Final Environmental Impact Report

**East Bay Municipal Utility District
Bayside Groundwater Project**

October 2005

FIGURE 1-2
UPPER SAN LEANDRO
RESERVOIR PRODUCTION
 EAST BAY MUNICIPAL UTILITY DISTRICT
 BAYSIDE GROUNDWATER PROJECT
 DRAFT EIR

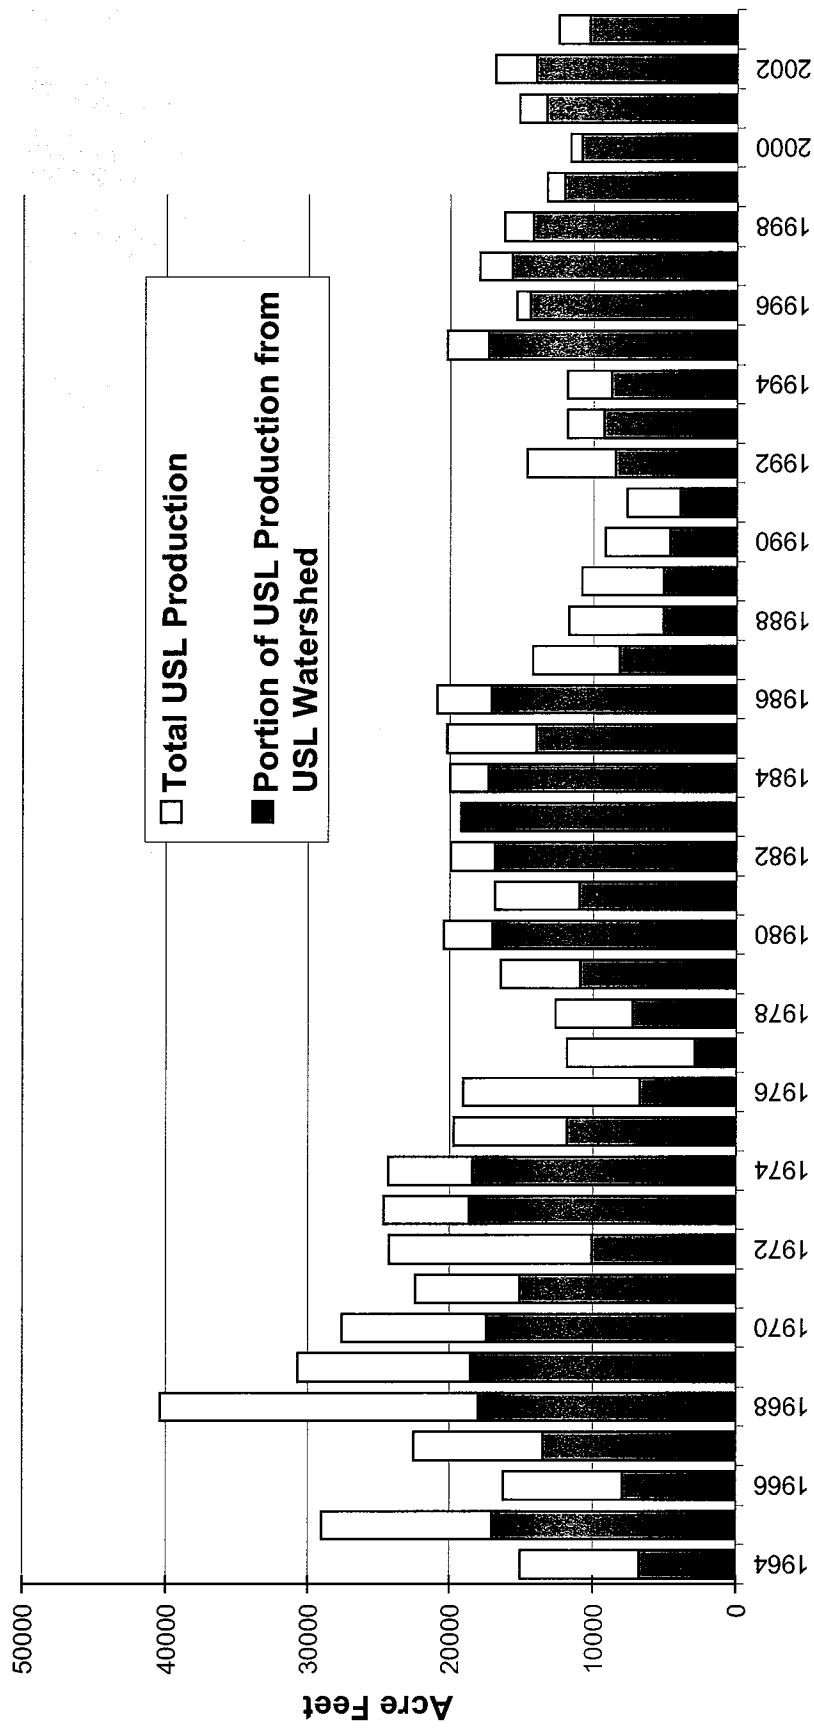
- L4-3 [3. We would like to see more data to support Sec. 1.4.4 and Figure 1-2. The years 1995-2005 are not shown. Thirty of the last 40 years of data are used to prove that USL runoff would be sufficient to inject into the deep aquifer. It would be more appropriate to use 20 of the last 20 years, which appears much less than the 15,000 A.F. noted by the report.

Figure 1-2 has been revised to show the 40-year period from 1964 to 2003 and can be found in Section 4.0 of this Final EIR. The purpose of the figure is to demonstrate that an examination of the historical hydrology provides a strong indication that in the future, sufficient runoff will be available to provide water for injection for the Bayside Groundwater Project.

FIGURE 3.1-2a
CROSS-SECTION LOCATION
 EAST BAY MUNICIPAL UTILITY DISTRICT
 BAYSIDE GROUNDWATER PROJECT

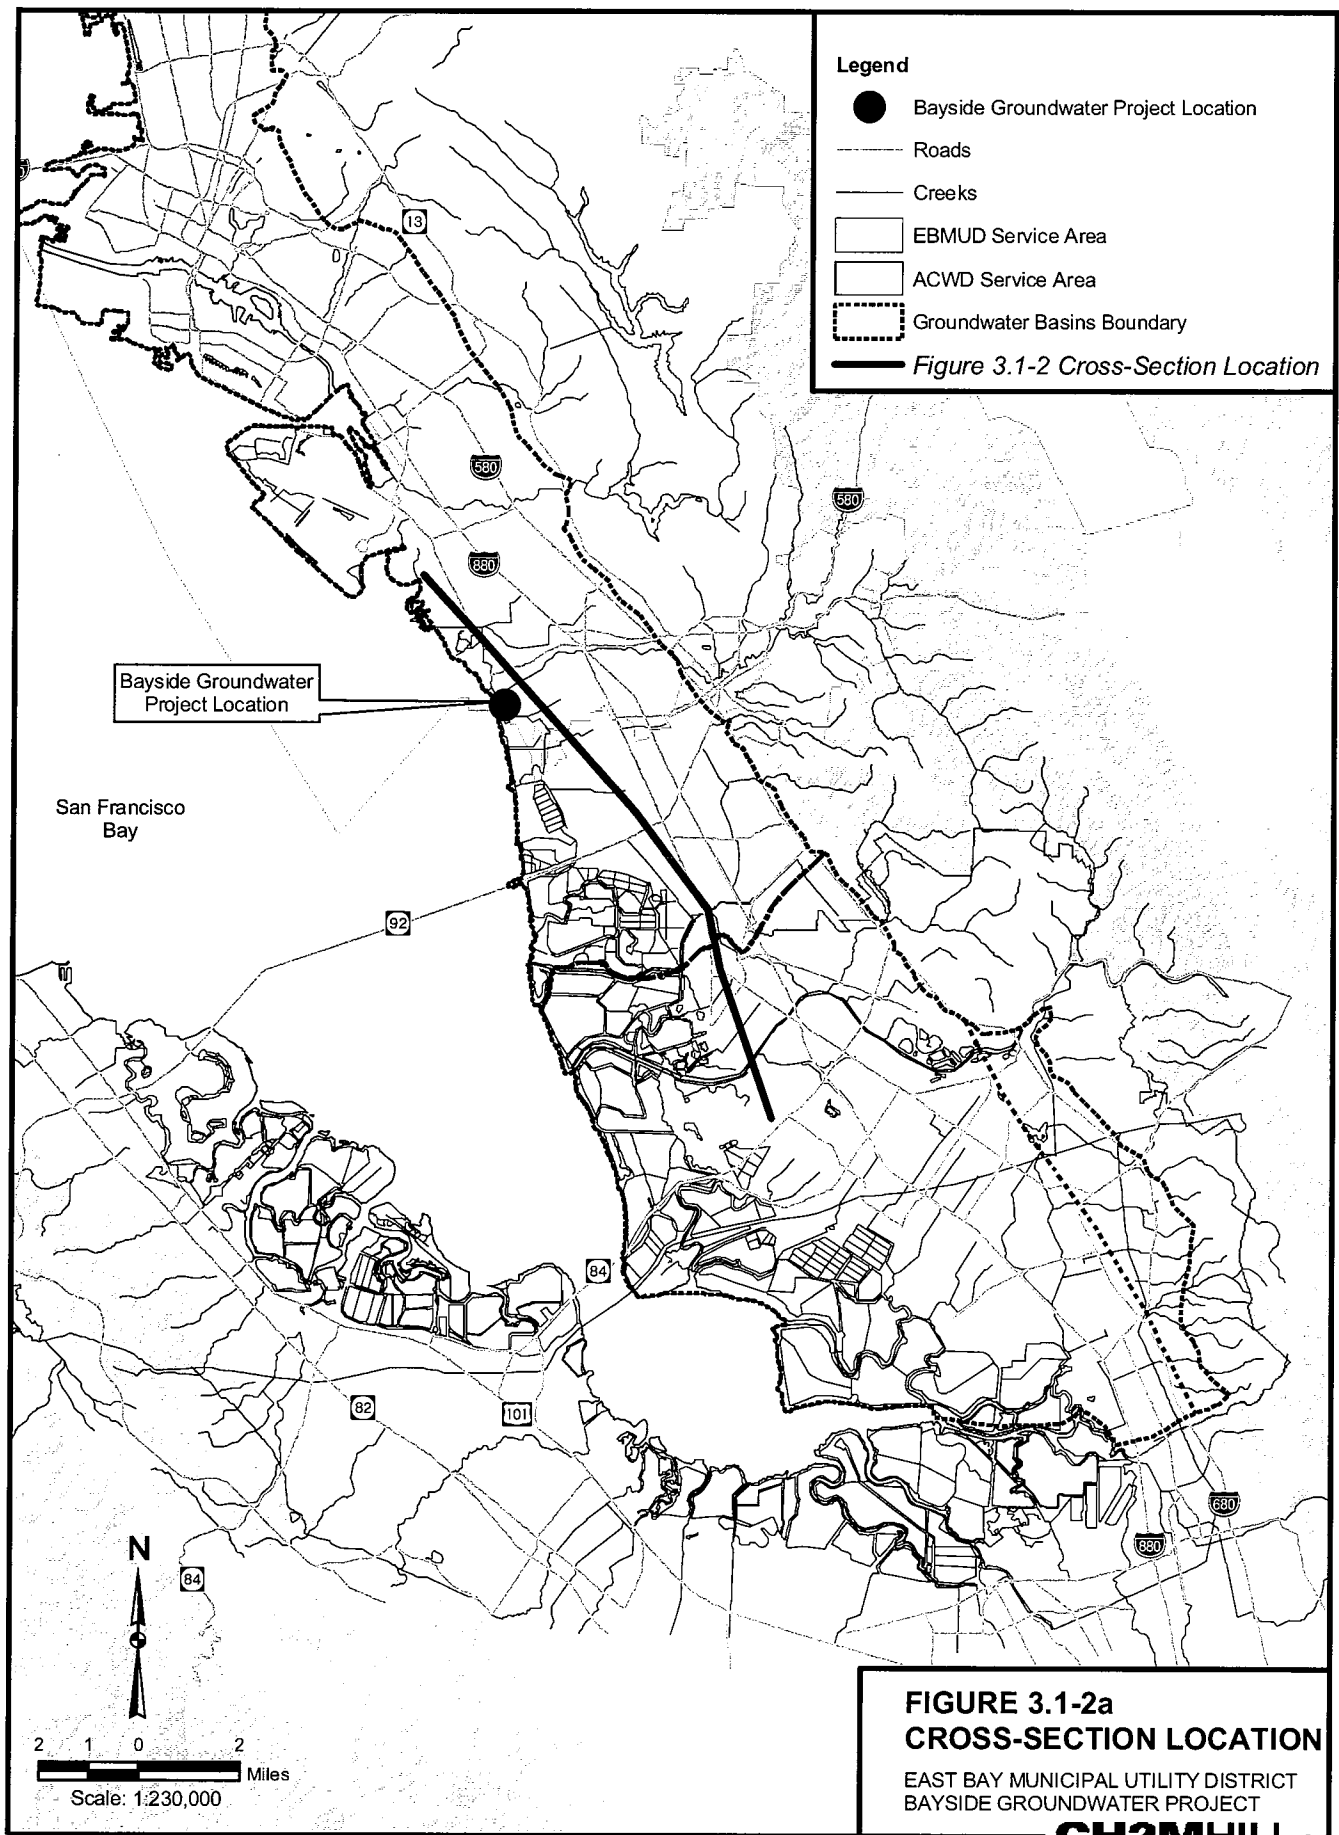
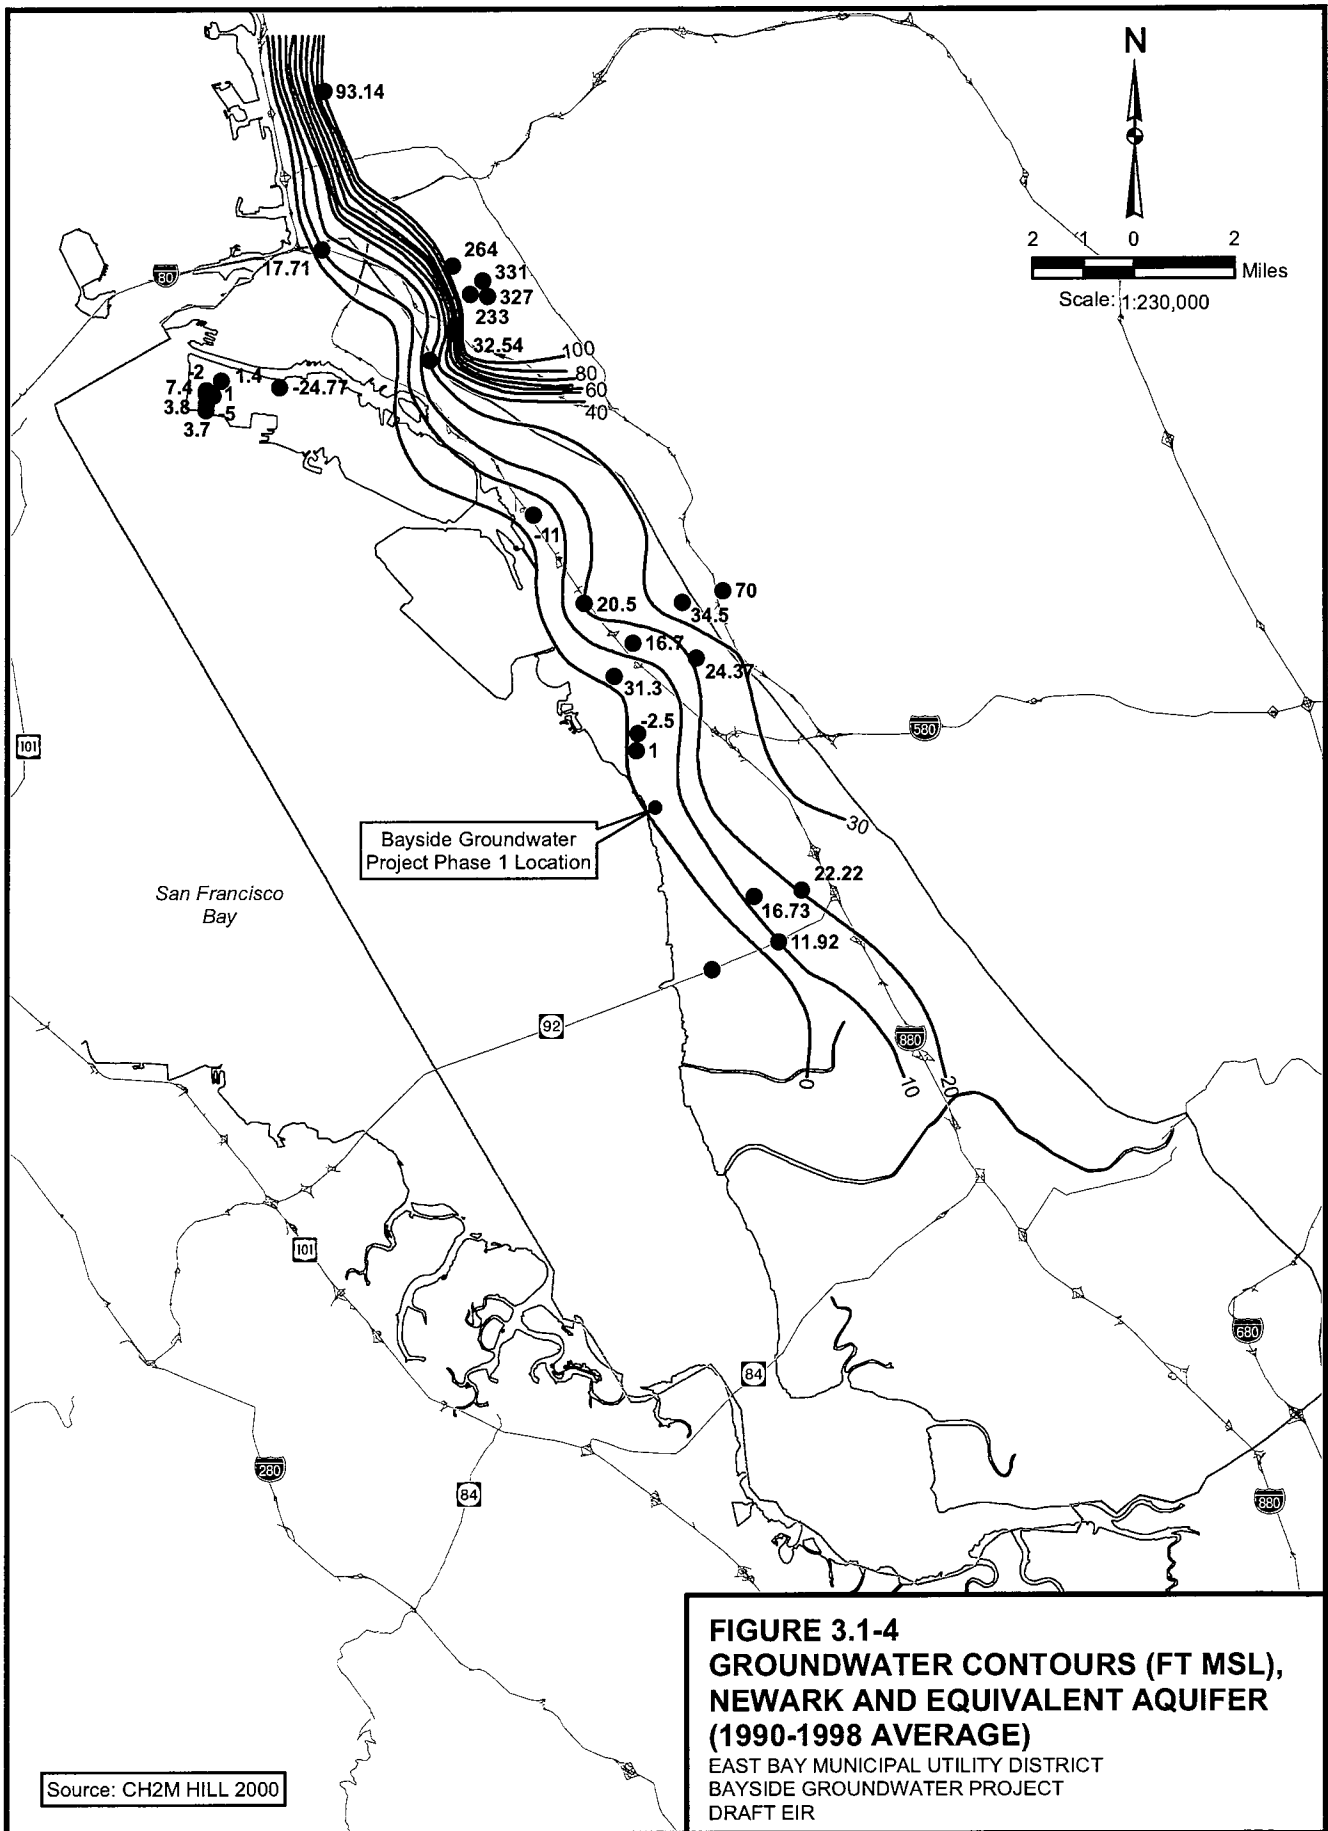
The cross-section shown in Figure 3.1-2 in the DEIR does not intersect San Francisco Bay. A plan view of the region showing the location of the cross-section is shown in Figure 3.1-2a, included in the errata section of this Final EIR. In addition, the depth of the Bay near the Proposed Project site is only a few feet, and would not be discernible on the scale (+200 to -1,200 feet) of the cross-section in Figure 3.1-2.

FIGURE 3.1-7
HISTORIC WATER LEVELS
SEBPA AND NCGWB

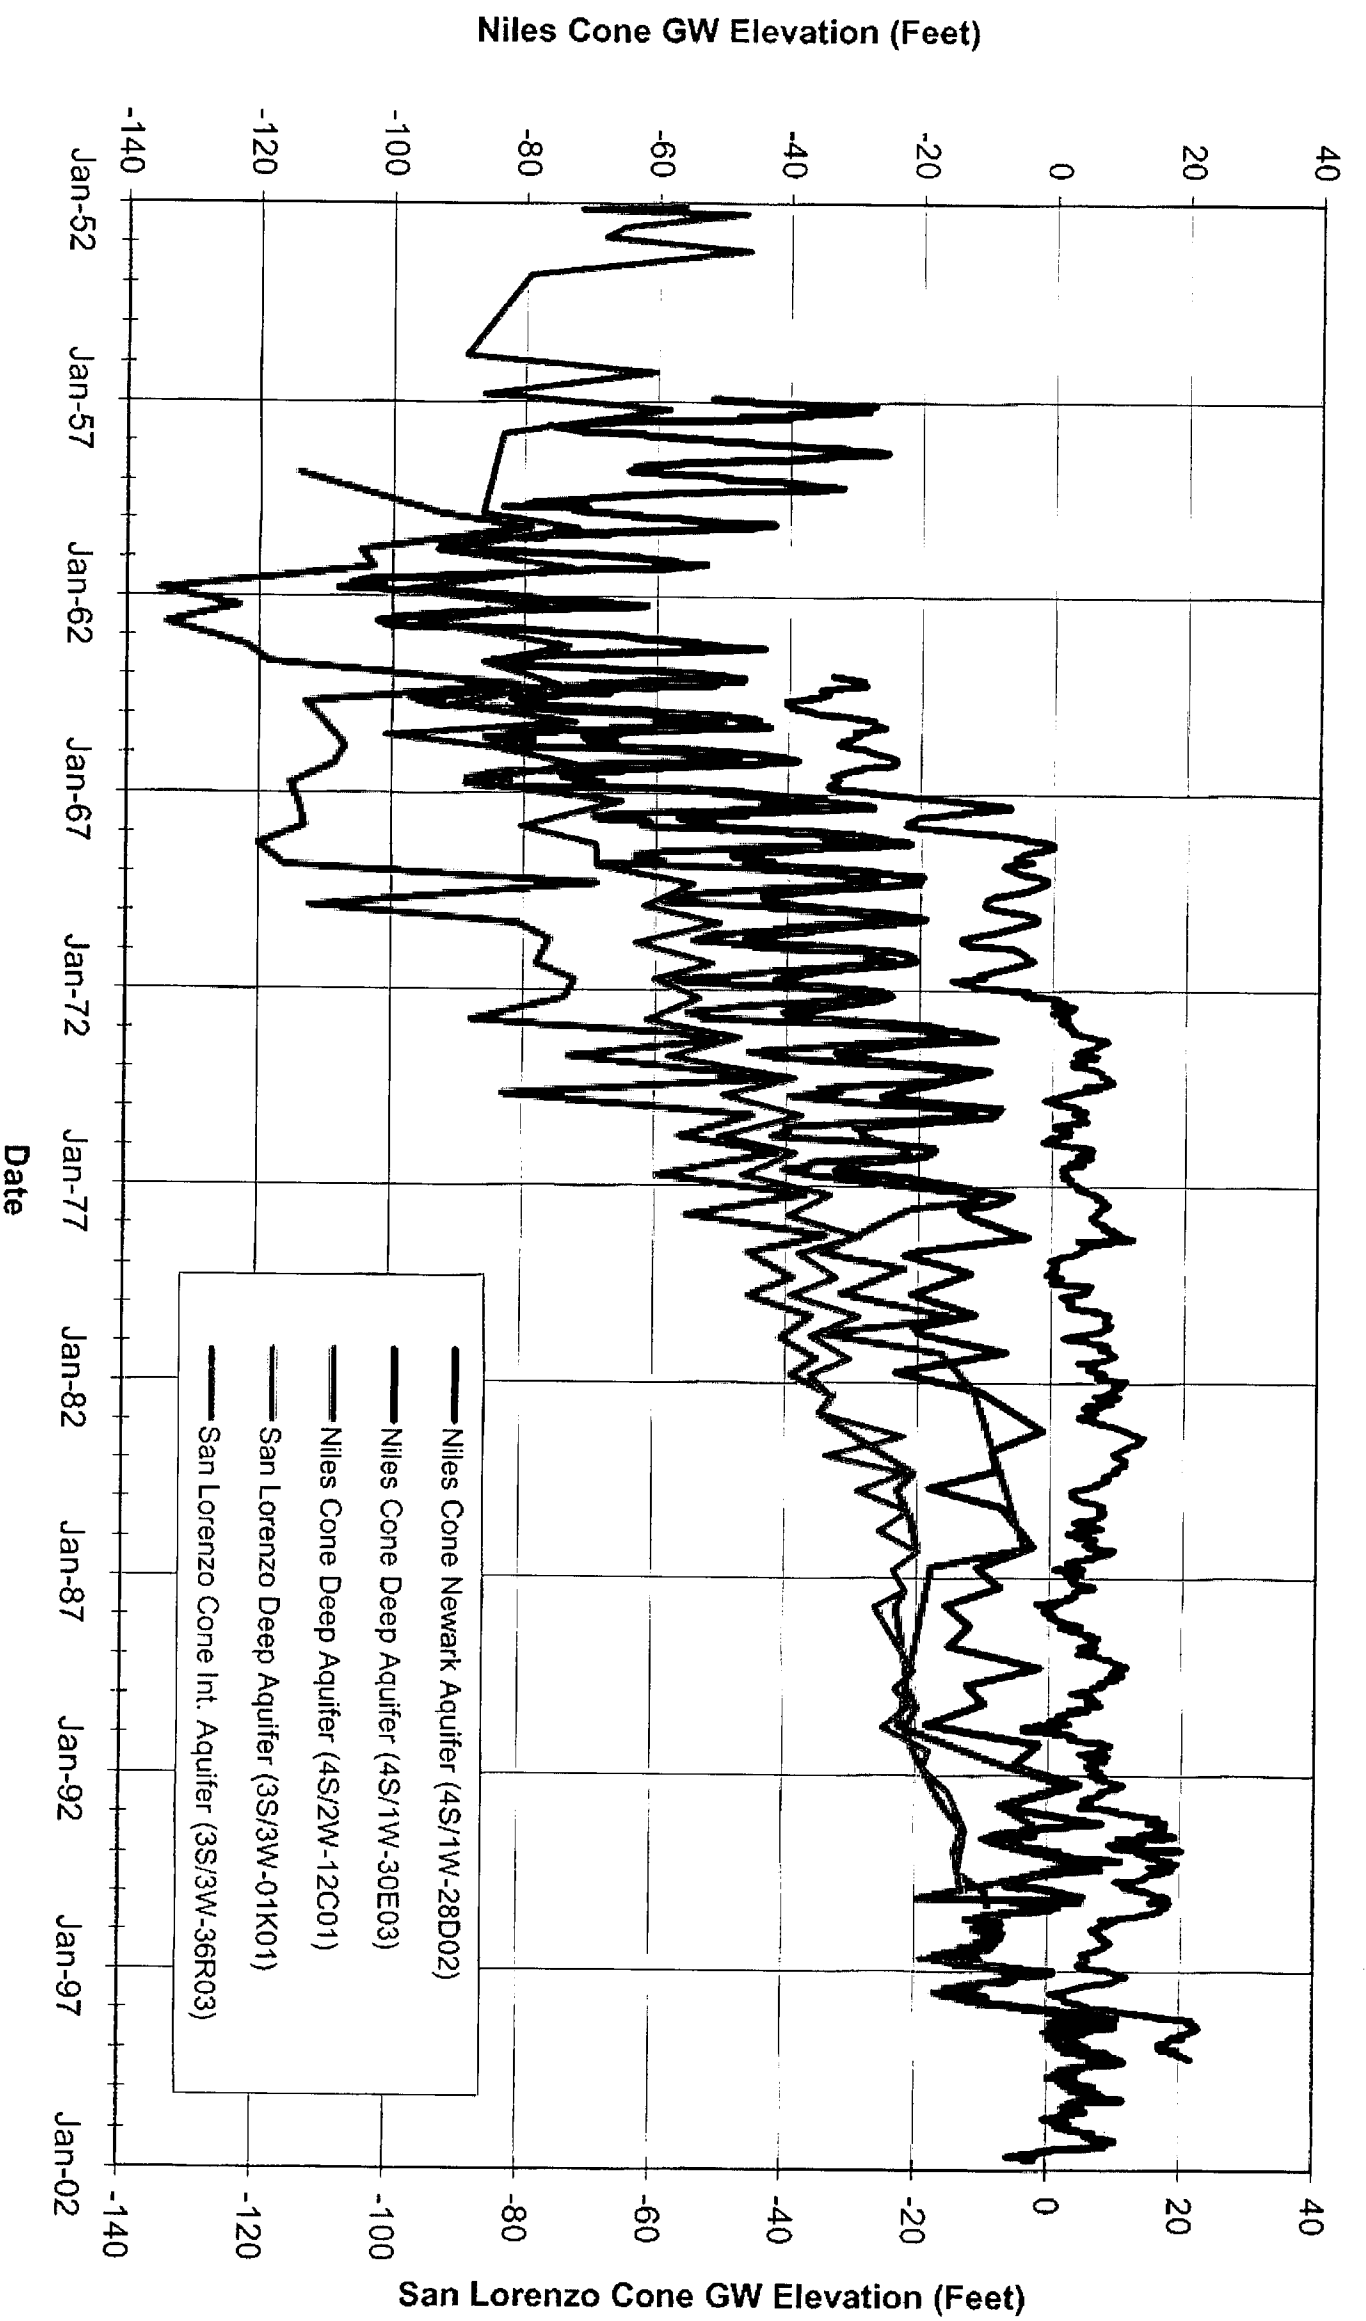
Comment #	Section	Page	Comment	Recommendation
19	3.1.2.2	3.1-11	Not all of the groundwater contours are labeled in Figure 3.1-4, Groundwater Contours (FT MSL), Newark and Equivalent Aquifer (1990-1998 Average). Figure 3.1-7, Historic Water Levels SEBPG and NCGWB, is difficult to read.	Complete the labels for the groundwater contours.
20	3.1.2.2	3.1-17	The Impacts and Mitigation Measures and Disinfection By-products Formation subsections do not adequately address the impact of disinfectant by-products (DBP) within the aquifer, which may degrade the aquifer and potentially pose a human health threat. This section indicates that during pilot studies trichloroethane (TCE) concentrations were produced in the aquifer at or near the MCL (80 µg/L); however, further discussion or mitigation was not provided.	Present the figure in landscape on 11 x 17 so that each trend is separated more. Revise this section to more adequately address THM and other DBP production and accumulation in the aquifer and identify how the data collected during the pilot studies relates to the proposed project. Specifically, compare the magnitude of pumping during the pilot study to anticipated pumping levels during Phase 1 and address whether DBP production will exceed MCLs. Evaluate the significance of this issue's impact and identify proposed mitigation measures.

As requested, Figure 3.1-7 has been printed on an 11x17 sheet. The larger print-out of Figure 3.1-7 is included in the errata section of this Final EIR.
